VIRGINIA ELECTRIC AND POWER COMPANY
RICHMOND, VIRGINIA 23261

VIRGINIA ELECTRIC AND POWER COMPANY (DOMINION)
SURRY POWER STATION UNIT 2
ASME SECTION XI RELIEF REQUEST
ALTERNATIVE ACCEPTANCE CRITERIA FOR SURFACE EXAMINATIONS

**Third Ten Year Interval
Relief Request SR-38**

**Alternative Requirements for the Acceptance Criteria for Surface Examinations on
Class 2 Austenitic Stainless Steel Pump Casing Welds**

Figure 1 Typical Low Head Safety Injection and Recirculation Spray Pump

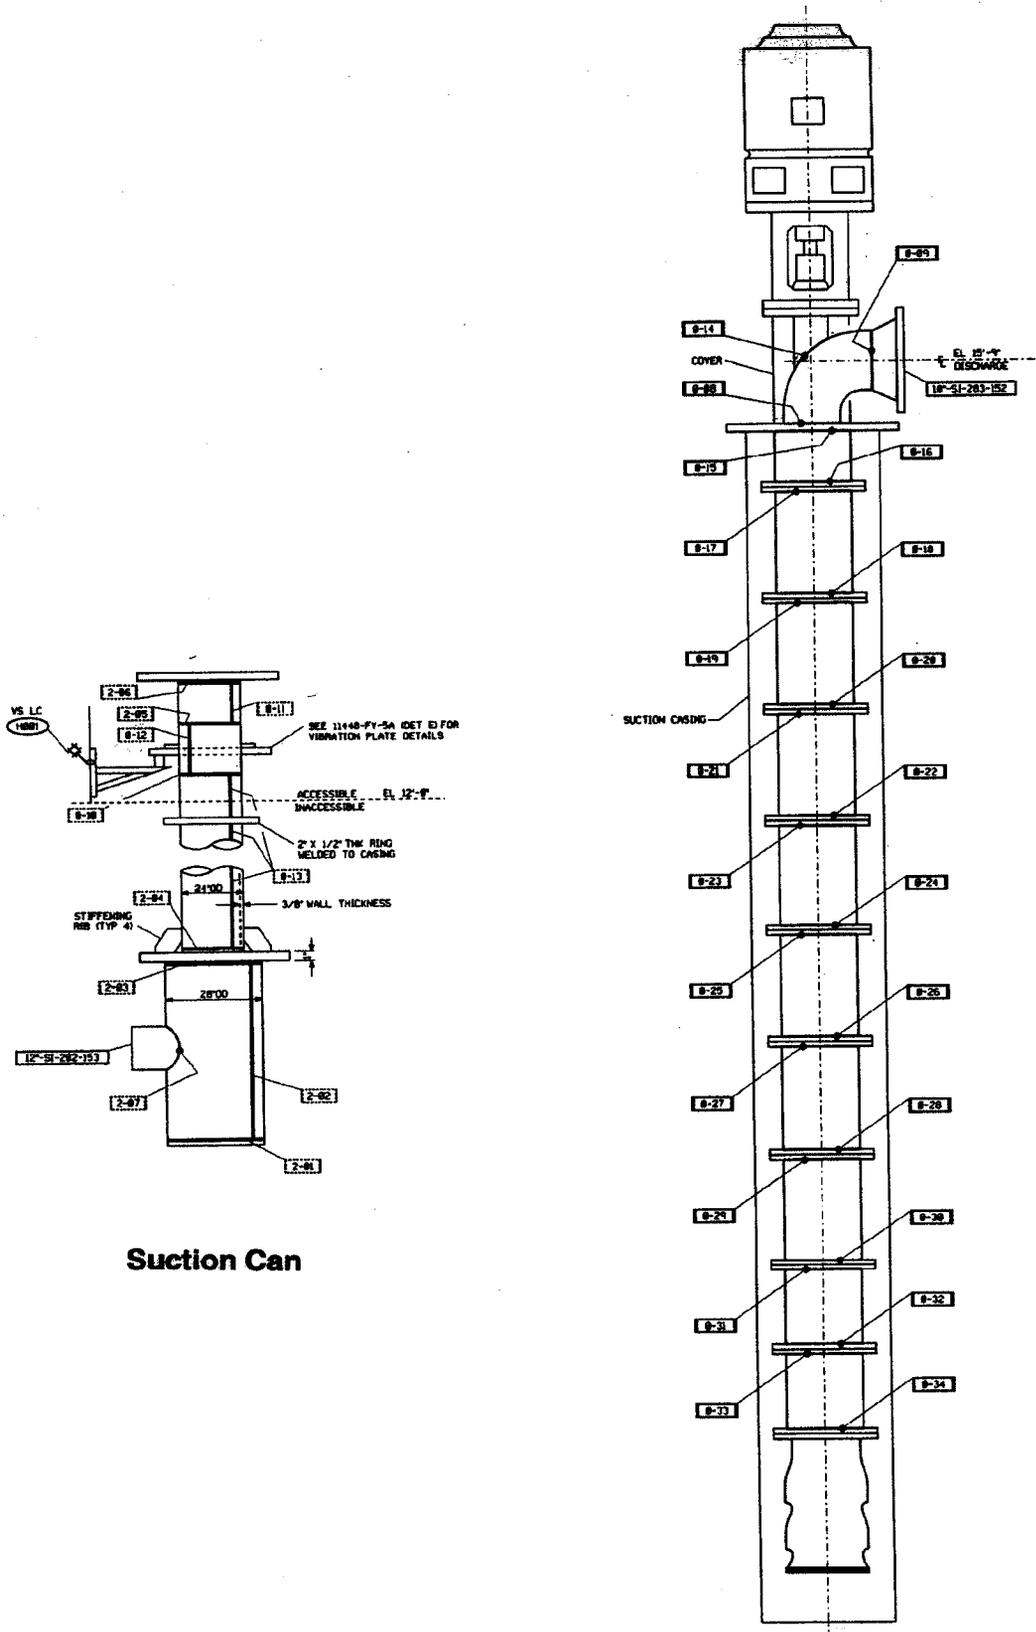
The pumps specified in this relief request are vertical, two-stage, centrifugal pumps with an extended shaft and casing that allows suction from the containment sump. This pump casing extends subgrade for more than 40 feet. The pump column consists of bolted flange sections made from austenitic stainless steel pipe. Circumferential welds exist at the pipe to flange locations. Verification of longitudinal welds cannot be made, but will be determined when the pump is disassembled and inspected. See Figure 1 for typical view.

The inspection standard specified in the Code for Class 1 and 2 pump casing welds, Table IWB-3518-2, is only for 2 inches or greater thickness. Dominion believes the pump columns were manufactured from schedule 40 pipe, which gives a nominal wall thickness of 0.365 inches. Therefore, the figures in Table IWB-3518-2 do not apply. However, the standards for austenitic piping provided in Table IWB-3514-2 are appropriate.

In accordance with the provisions of 10CFR50.55a(a)(3)(i), approval is requested to use Table IWB-3514-2, Allowable Planar Flaws (which is applicable to austenitic stainless steel piping) from the 1989 Edition of ASME Section XI as an alternative to the evaluation requirements of Table IWC-2500-1 for examination of category C-G pump column casing welds. The pump column is fabricated from bolted flange sections of austenitic stainless steel pipe with circumferential welds at the pipe to flange locations and possible long seam welds. Therefore, using acceptance criteria for austenitic stainless steel pipe would be more appropriate than the acceptance criteria intended for much thicker pump casings and would provide an acceptable level of quality and safety.
